Subject: Transmittal of Revision 3 to Service Bulletin Number
V2500-ENG-72-0192

International Aero Engines
SERVICE BULLETIN

ENGINE - TURBINE EXHAUST CASE ASSEMBLY AND FITTINGS -
REMOVE THE TURBINE EXHAUST CASE FAIRING

72-50-00

Figure 1 (Sheet 1)

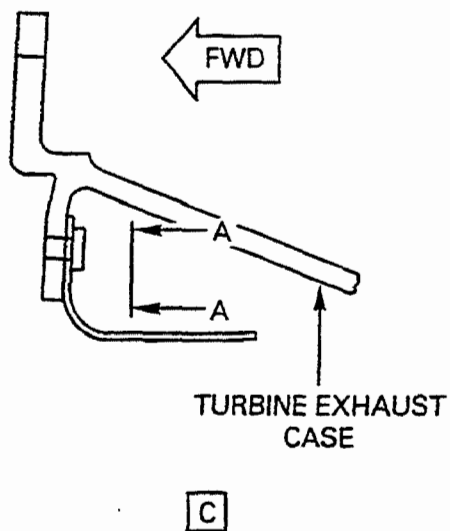
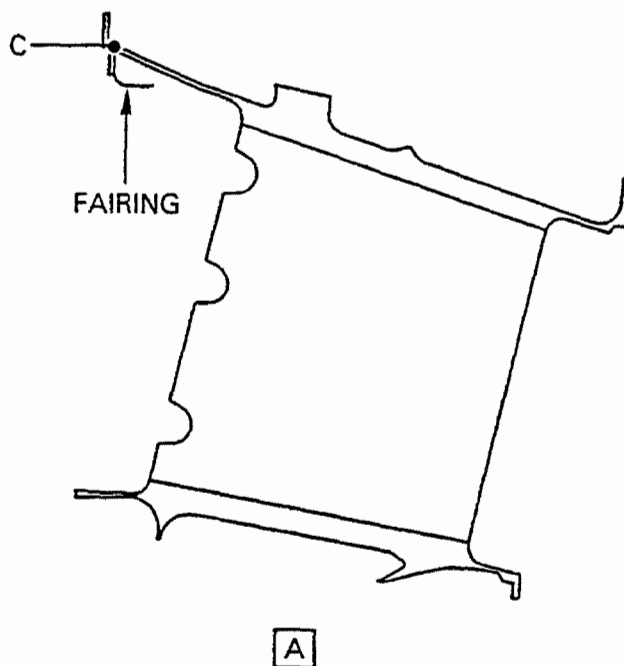
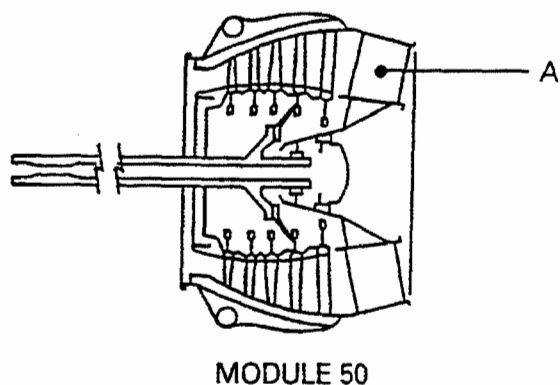
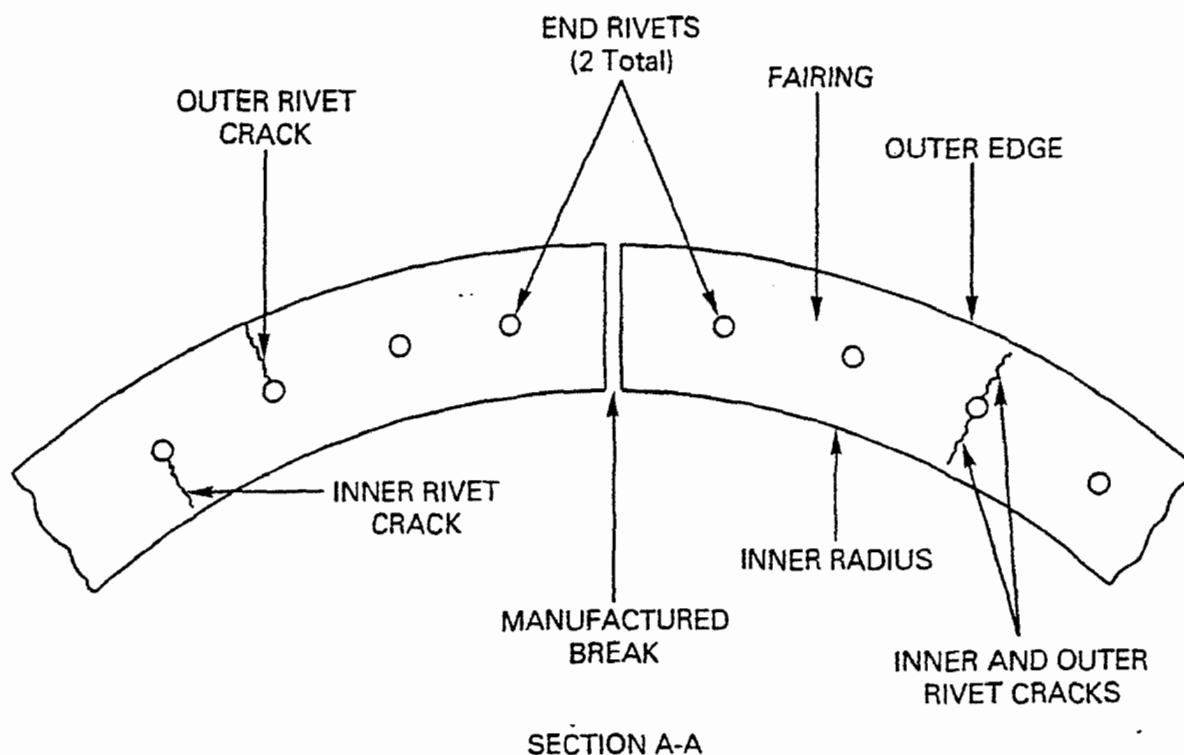
Fairing Inspection - Table 1		
Inspection Area	Condition	Necessary Procedure
1. All areas (Figure 1)	No cracks.	Inspect again at the next 2 "A" Check.
2. Outer rivet crack - in relation to the rivet circle. (Figure 1)	Cracks - outer area only. (No limit)	Inspect again at the next 2 "A" Check.

3. Inner and outer rivet cracks, both sides of rivet circle, at end rivet locations. (The end rivets are the 2 rivets adjacent to the manufactured break. [Figure 1])	Cracks with total length equal to more than fifty percent of the distance between the fairing outer edge and the inner radius.	Remove the Fairing immediately by the procedure given in Paragraphs B through D.

4. Inner and outer rivet cracks, both sides of rivet circle. (Figure 1)	Cracks at any two rivets, adjacent to each other, when the total length is equal to more than fifty percent of the distance between the fairing outer edge and the inner radius.	Remove the Fairing immediately by the procedure given in Paragraphs B through D.

5. Inner and outer rivet cracks, both sides of rivet circle. (Figure 1)	Cracks at a maximum of 15 rivet holes. Cracks cannot be at adjacent rivets, and cannot be at the two end rivets.	Inspect again at the next 2 "A" check.

6. Inner and outer rivet cracks, both sides of rivet circle. (Figure 1)	Cracks in both directions from the rivet, radially in and out, at more than fifteen locations.	Remove the Fairing immediately by the procedure given in Paragraphs B through D.

7. All areas (Figure 1)	Damage other than 1 through 6.	Inspect again at the next 2 "A" Check.

Figure 2

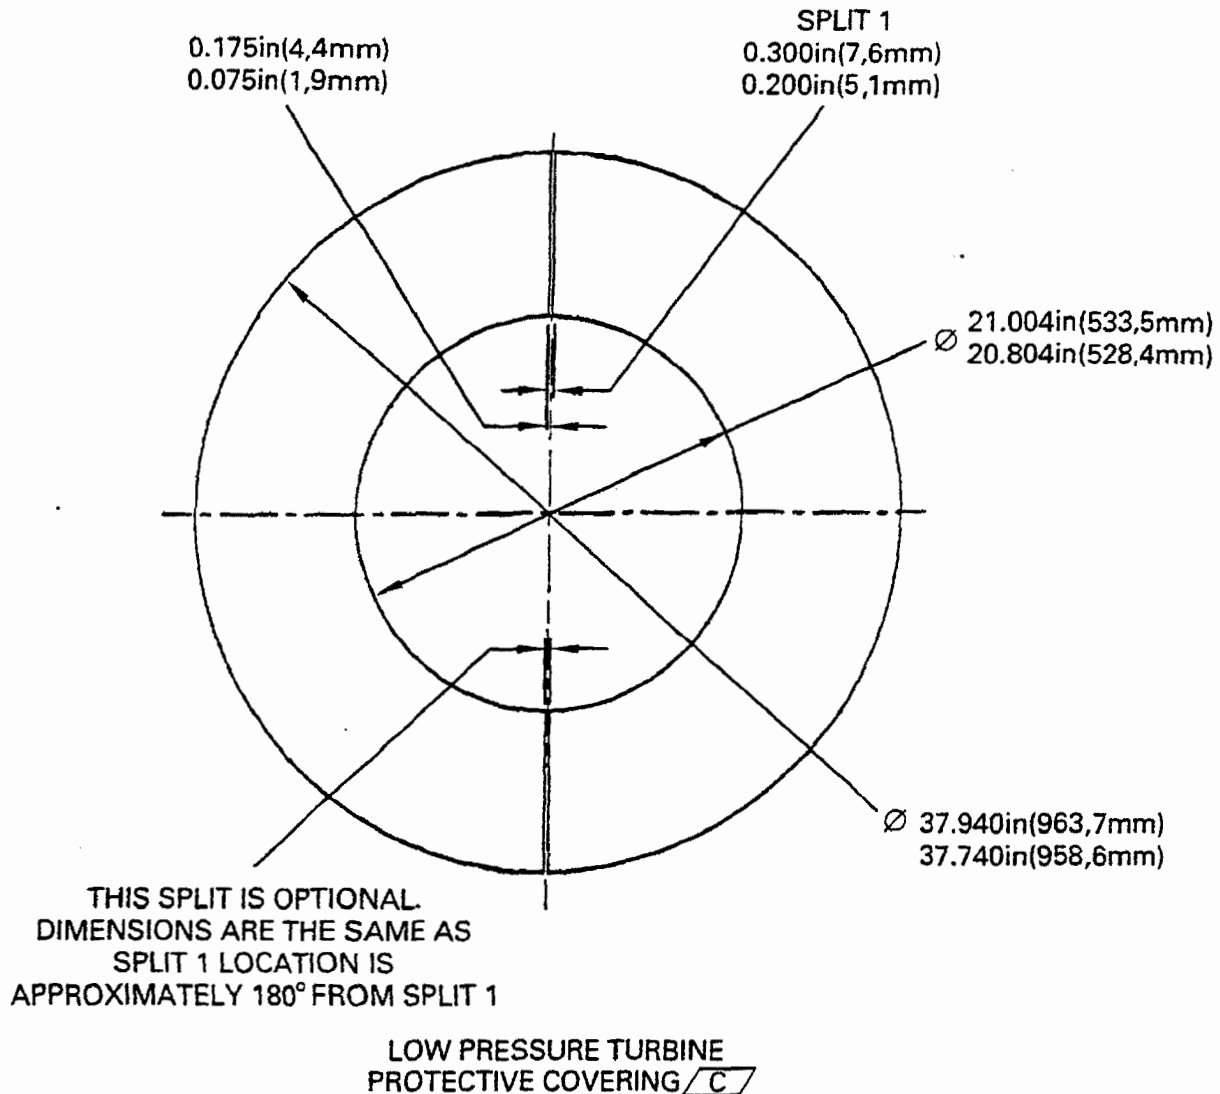
(1) Make a Low Pressure Turbine (LPT) protective cover (C) from a sheet of flexible plastic 0.020 to 0.040 in. (0,51 - 1,02 mm) thick. See Figure 2 for the necessary dimensions.

Install the Low Pressure Turbine Cover
and Strut Leading Edge Protection
Figure 3 (Sheet 1)

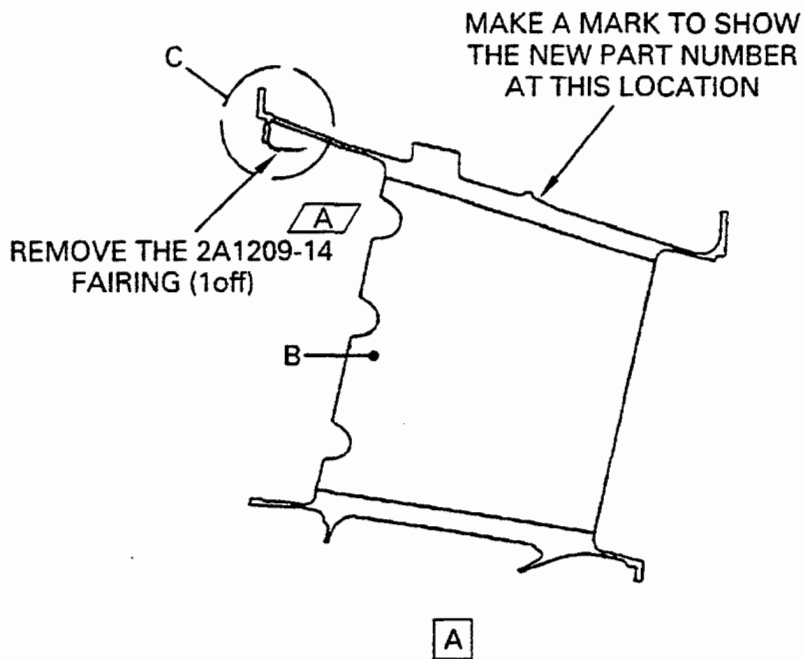
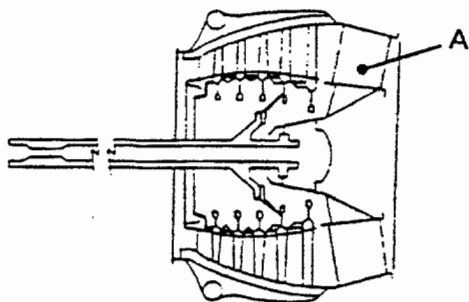
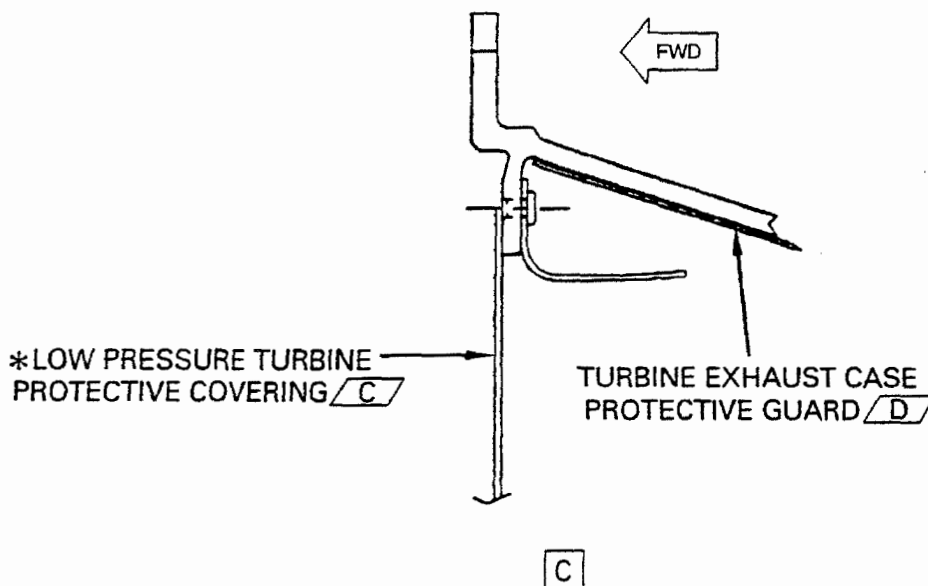
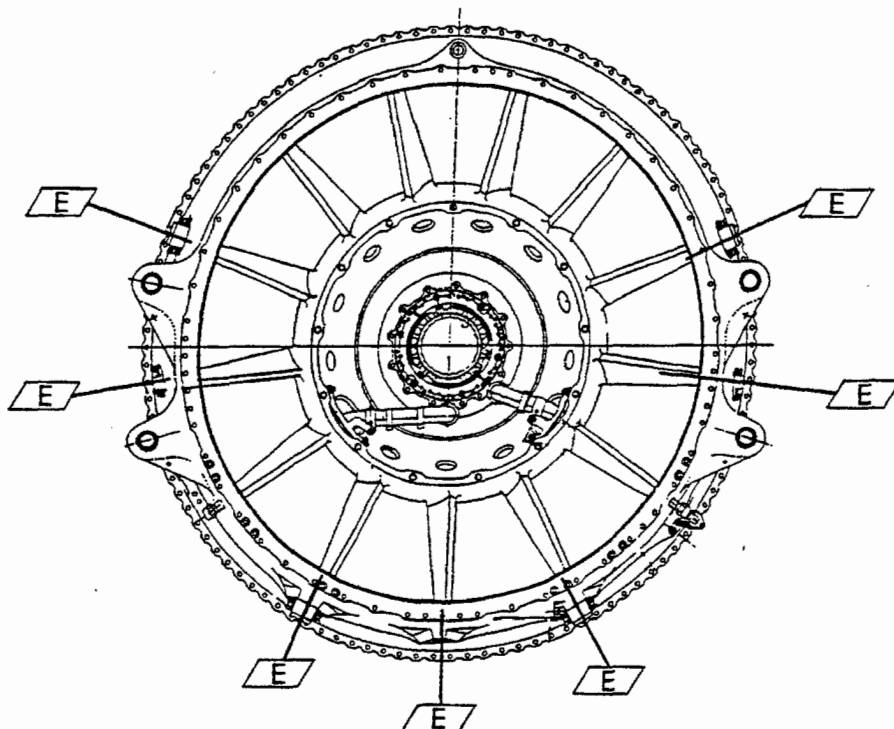
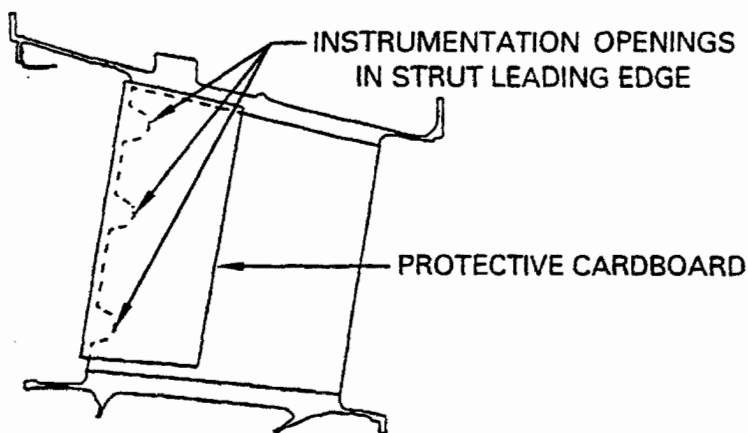
(2) Attach the LPT protective cover by Figure 3 and the procedure that follows:

1 Position the cover as shown in Figure 3.

NOTE: If the cover is made in two halves, install as shown in Figure 3. Form a complete ring and cover both splits with tape.

(3) Apply masking tape to protect the instrumented strut leading edges. See Figure 3.

(4) Install cardboard covers for protection on all strut leading edges. See Figure 3.

(7) Install the Turbine Exhaust Case guard next to the rivet that you will grind. See Figure 3.

Make The Turbine Exhaust Case Guard
(Protection Against Damage)
Figure 4

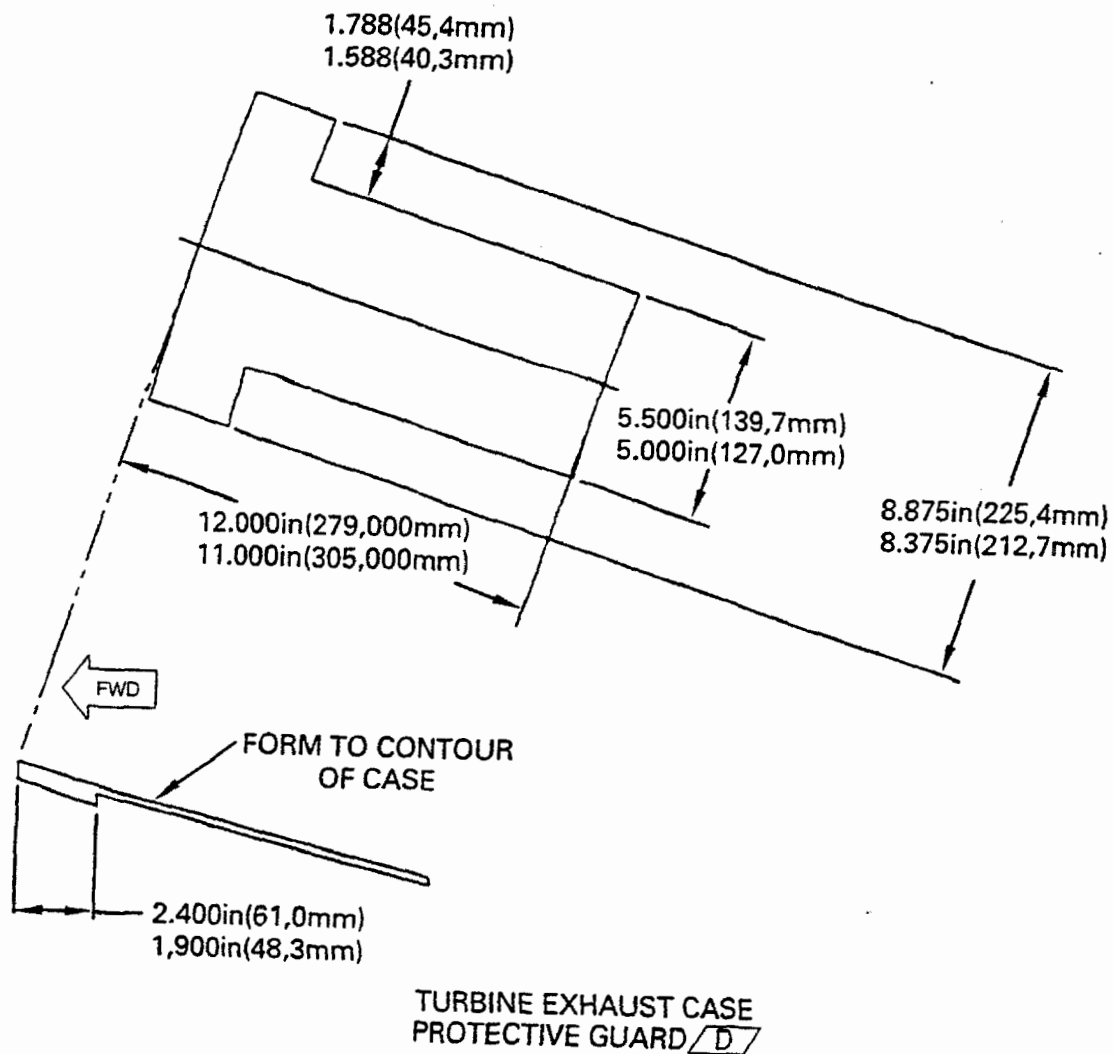
(6) Make a Turbine Exhaust Case protective guard to the dimensions given in Figure 4 and as follows:

(a) Use sheet metal that is 0.02 - 0.04 in (0,51 - 1,02 mm) thick.

(b) Make the guard so that the contour is the same as the surface it will touch on the Turbine Exhaust Case.

Figure 5.

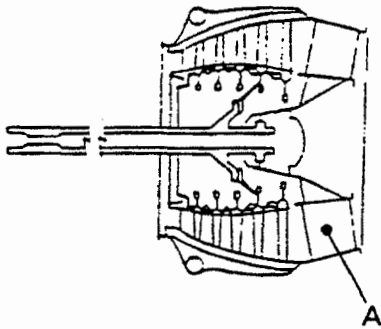
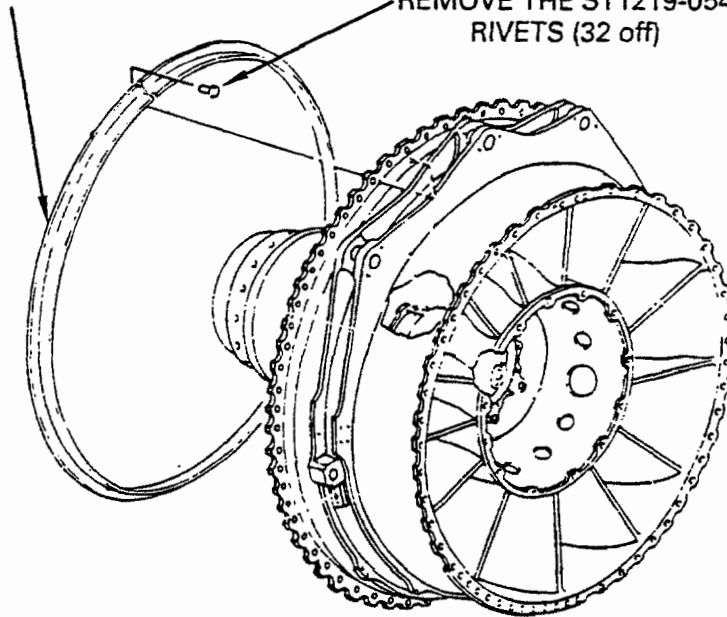
- (8) Bend the fairing (A) toward the center of the Turbine Exhaust Case. See Figures 5 and 6.
- (a) Start at the manufactured break in the fairing.
 - (b) Use the applicable guards for protection of the engine parts.
 - (c) Pry the fairing inboard, approximately 45 degrees in relation to the case centerline.
- (9) Grind the rivet heads (E) at 32 locations by Figure 6 and as follows:

USE A GRINDING WHEEL AS SHOWN IN FIGURE 5 TO MINIMIZE THE RISK OF DAMAGE TO THE LOW PRESSURE TURBINE AND THE TURBINE EXHAUST CASE.

REMOVE THE 2A1209-14
FAIRING (1 off)

REMOVE THE ST1219-054
RIVETS (32 off)

Grind to Remove the Turbine
Exhaust Case Fairing
Figure 6 (Sheet 1)

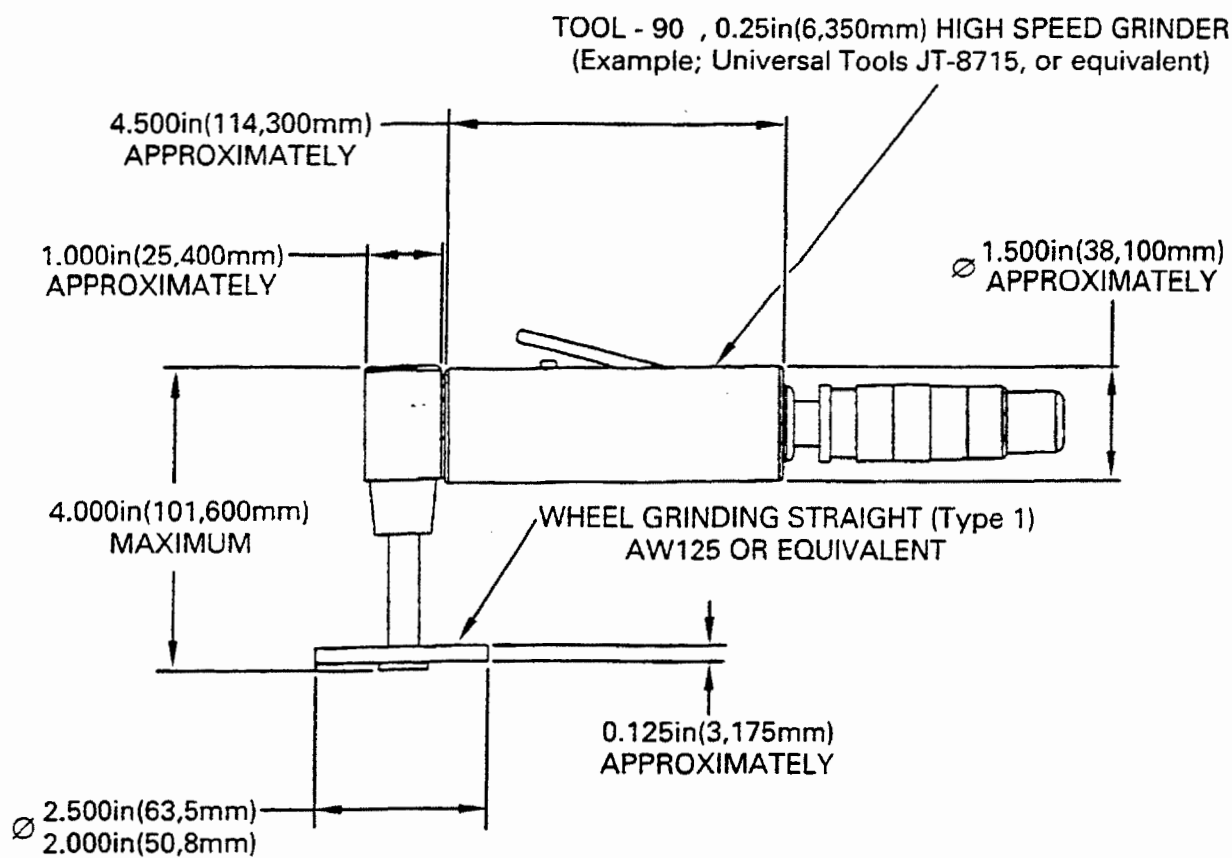
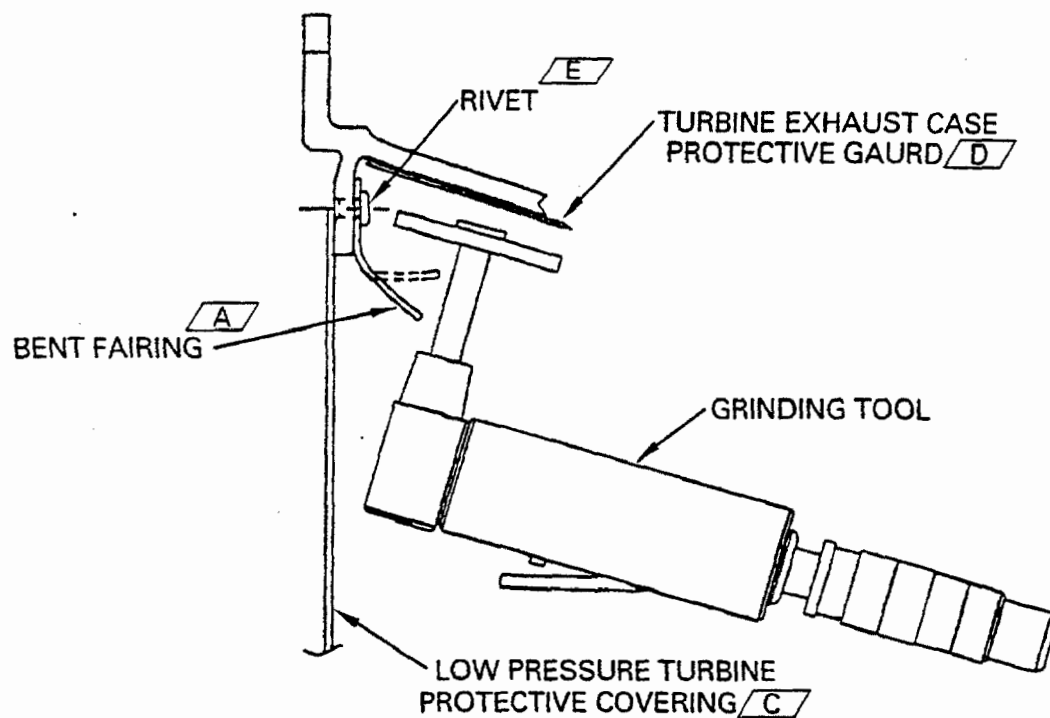
- (a) Use a guard for protection and to prevent damage to the Turbine Exhaust Case wall.
 - (b) Do not grind through the fairing.
- (10) Remove the fairing by the procedure that follows:
